SUBJECT: W.P. 181-67-02, Site 15-41,
Indian River Bridge,
(3.1 Miles North of Highway 44),
Highway 29, District 9 - Ottawa

FOUNDATION INVESTIGATION REPORT
For
New Structure at the Crossing of Hwy. #29
And the Indian River
Twp. of Ramsay, County of Lanark
District No. 9 (Ottawa)
W.O. 72-11089 -- W.P. 181-67-02

Indian River Bridge,
3.1 Miles N. of Hwy. 44,
W.P.#181-67-02, Site #15-41,
Hwy. #29, District #9.

FOUNDATIONS OFFICEREVIEW OF DESIGN DRAWINGS:

FOUNDATION LAYOUT & REINF.

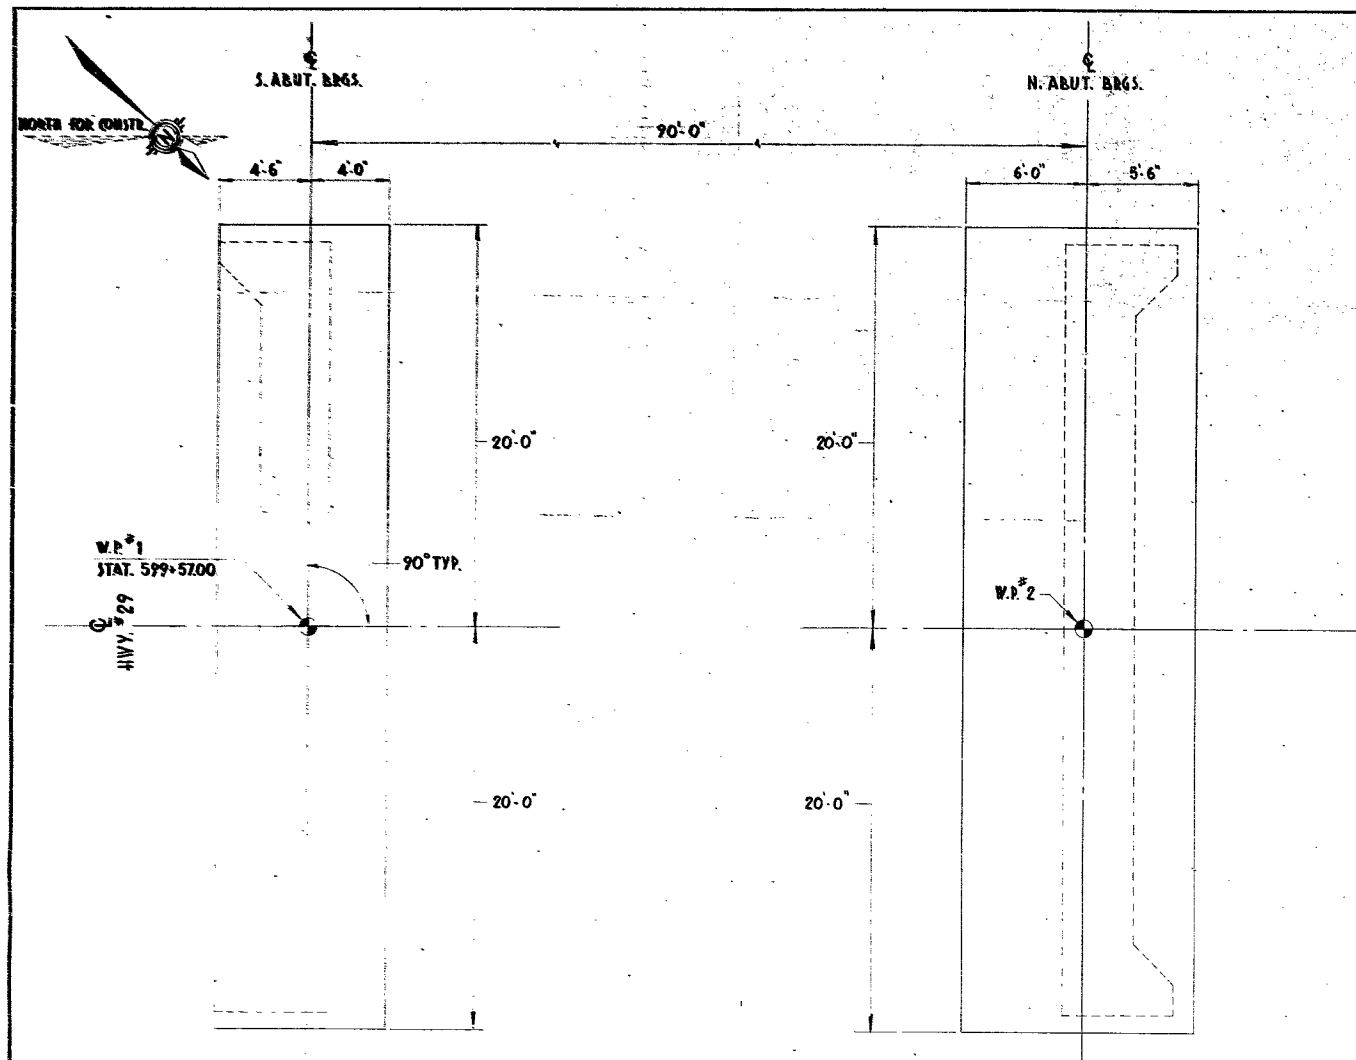
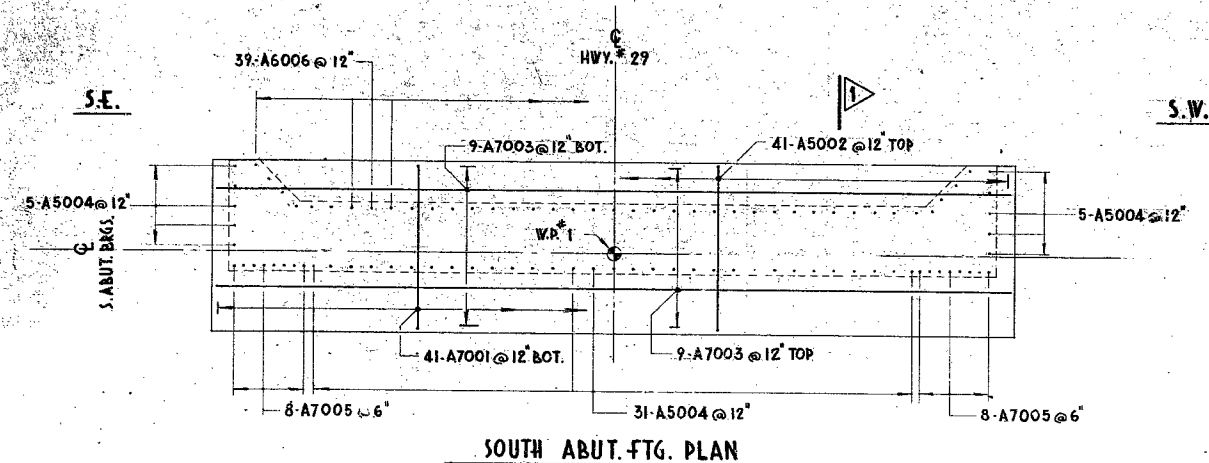
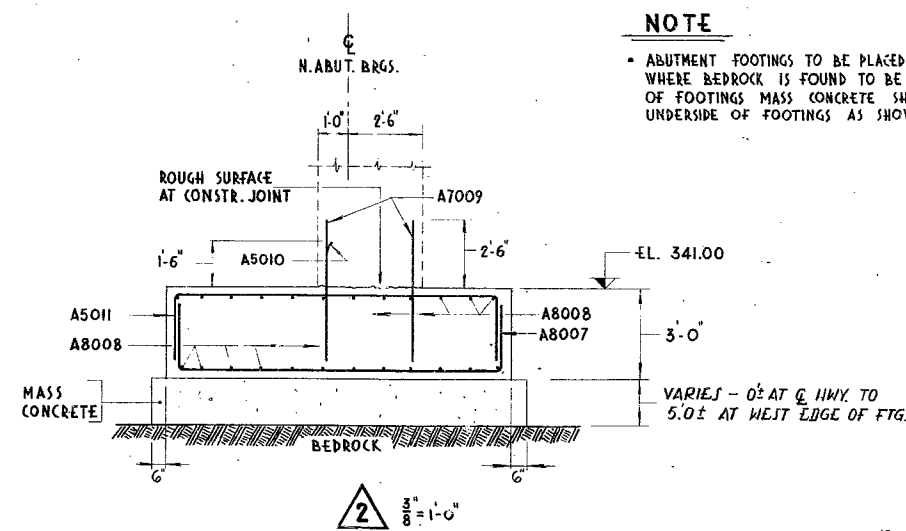
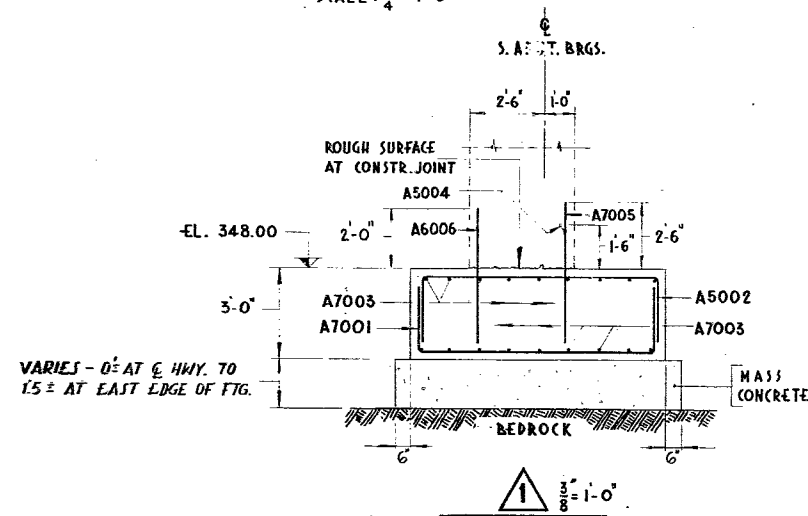
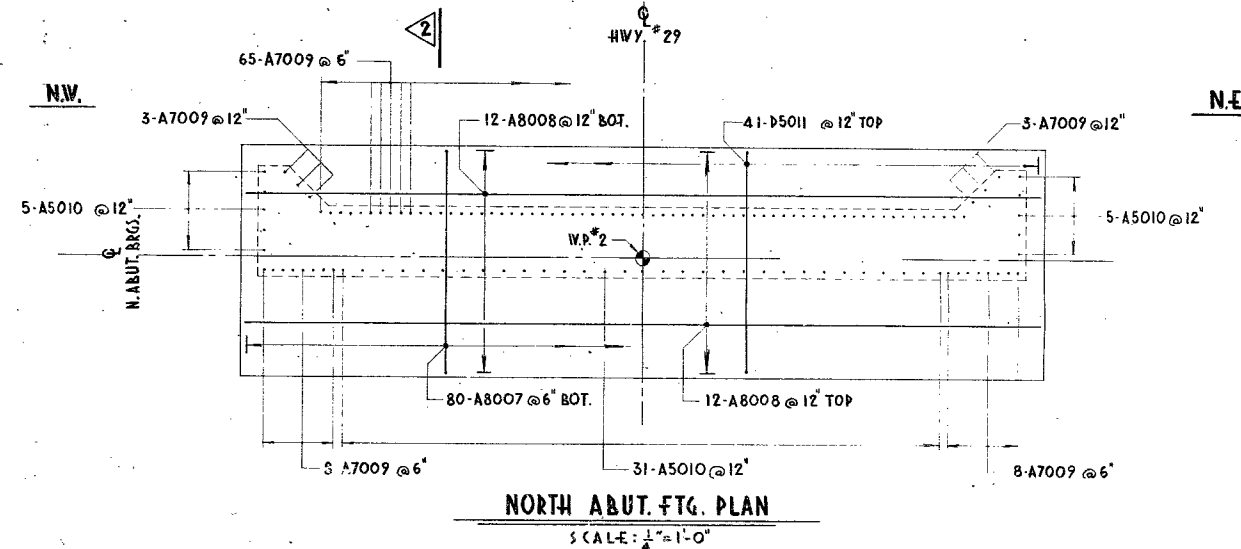
Excavation for the north abutment will be below the water level. Some dewatering measures may be required.
M. Devata
May 14/73

8. Summarize your comments; on separate sheet if necessary. *DEWATERING - NORTH ABUTMENT in flood season.*

*Actual Bedrock elevations for footings have to be confirmed
by an Engineer at the site during the excavations.*

DEWATERING ~~SCHEME~~ MAY BE REQUIRED FOR THE NORTH ABUTMENT.
8. Summarize your comments; on separate sheet if necessary.
